# Australian Pipeline Trust

## ROMA – BRISBANE PIPELINE NETWORK

### Optimised Replacement Cost Study

DOCUMENT NO: 167-R-02

Figure 1 - Pipeline Pressures

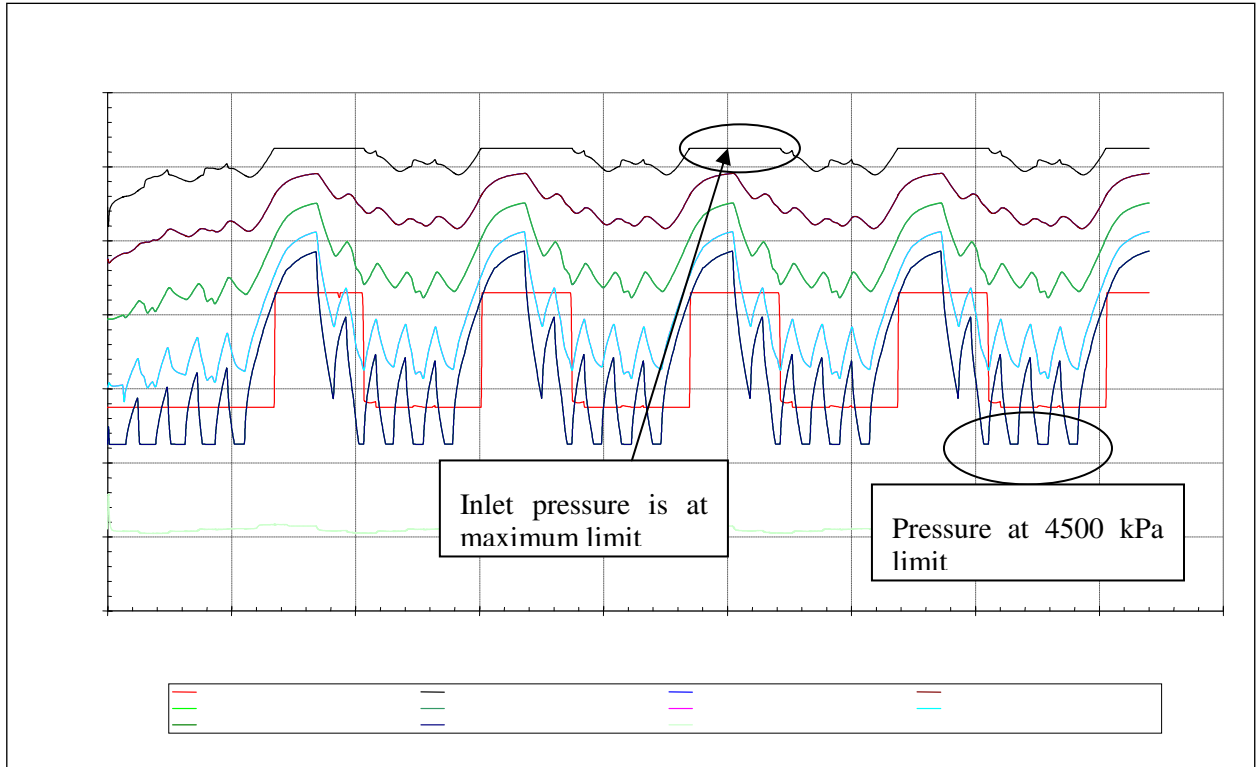
**Figure 1 - Pipeline Pressures** shows that:

1. The compressor discharge pressure at Wallumbilla reaches maximum inlet pressure about 2/3 through the weekend pipeline packing cycle, and remains at that value for about 50% of the weekly cycle.
2. The delivery pressure at Swanbank falls to the minimum value (4,500 kPa) on the 2<sup>nd</sup>, 3<sup>rd</sup>, 4<sup>th</sup>, and 5<sup>th</sup> cycle day. When the model maintains the delivery pressure at minimum value, it means that flow to the load is curtailed.

Figure 2 Inlet and Outlet Flows

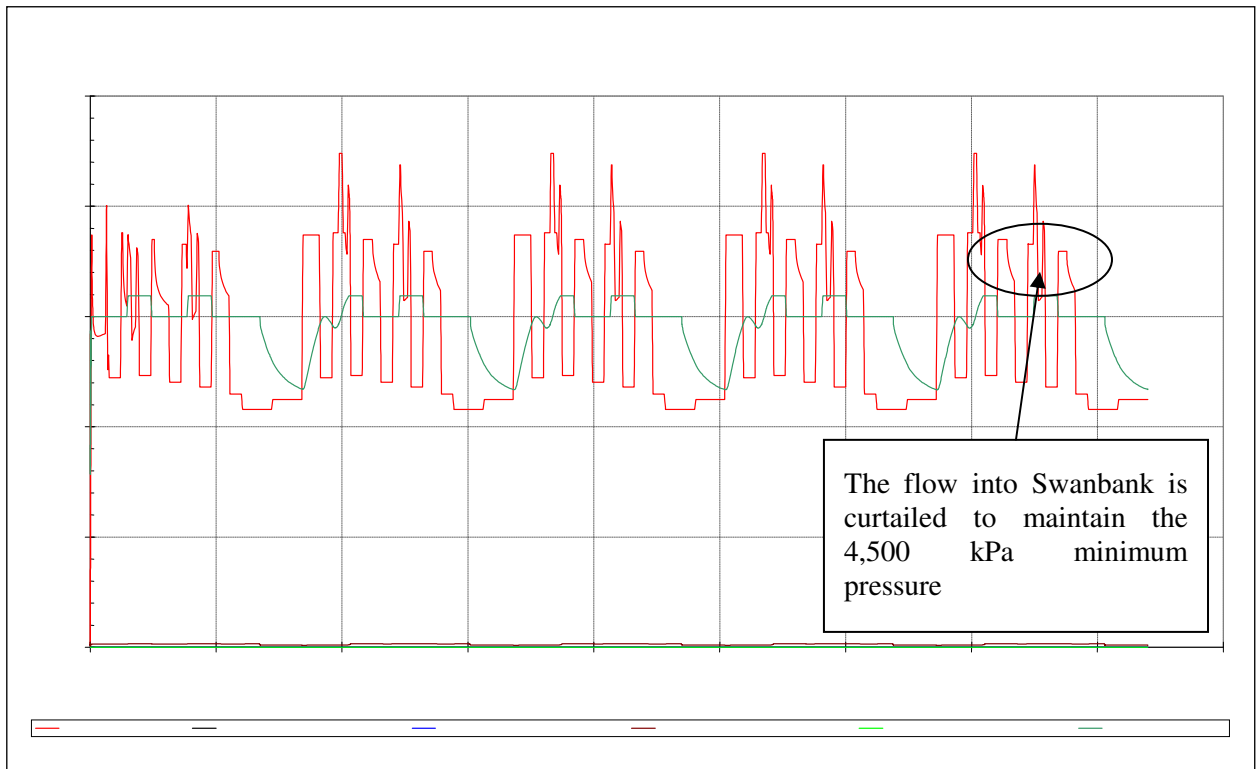
**Figure 2 Inlet and Outlet Flows** shows that:

1. The pipeline inlet flow is curtailed during each weekend packing cycle, because the pipeline inlet pressure (Wallumbilla) is at the maximum pressure, and it is not possible to accept more gas without installing another compressor in the pipeline.
2. The delivery flow to the Swanbank power station is curtailed on the 2<sup>nd</sup>, 3<sup>rd</sup>, 4<sup>th</sup>, and 5<sup>th</sup> cycle day (instead of the load being a rectangular shape, the flow at the latter part of the delivery cycle is truncated. This is consistent with the pressure at the Swanbank delivery point falling to the minimum value.

**Figure 3 Compressor Power**

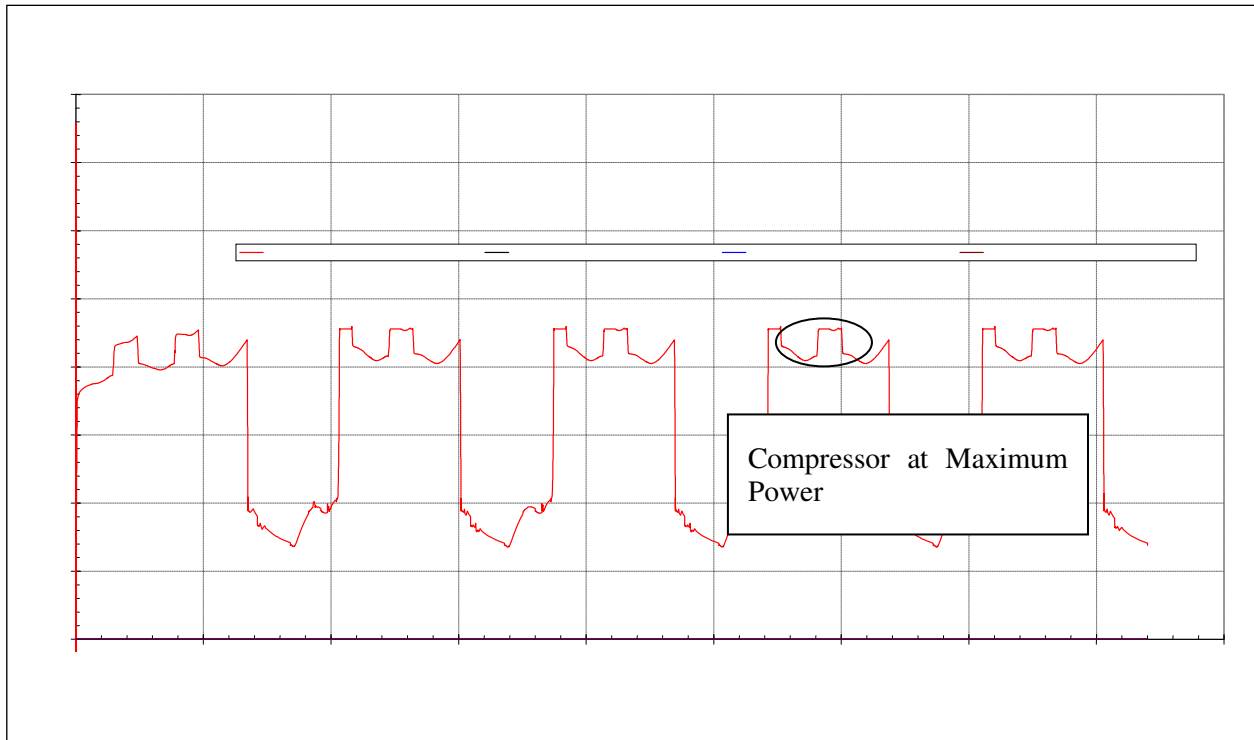
**Figure 3 Compressor Power** shows that the compressor power cannot be utilised during the packing part of the operating cycle (Saturday and Sunday). This is because the pipeline inlet pressure is at the maximum possible value.
